Errata Documentation

Product	Part Number	Description	Status
PCI 9656BA	PCI9656-BA66BI	64-bit 66MHz PCI, 32-bit 66MHz Local, PBGA Package	Production Released

8. PME# Pin Isolation

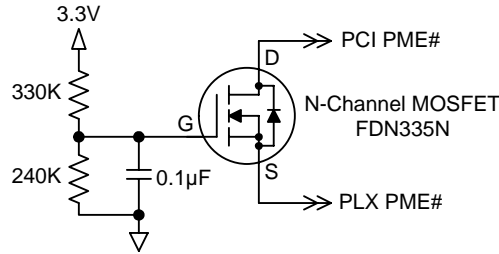
Documented Behavior: Components that support the PCI Power Management D3cold state and implement PME# must ensure that, whenever main power is removed, the non-powered PME# generating logic and its output do not present a low impedance path to ground. Otherwise, there could be an accidental system wake up event.

Actual Behavior: The silicon does not ensure such protection and does present a low impedance path to ground when in the D3cold state, essentially causing an accidental wake up event every time the add-in card is inserted.

If PME# is to be implemented, an external FET must be inserted between the silicon's PME# signal pin and the PCI Slot. Suggested circuit:
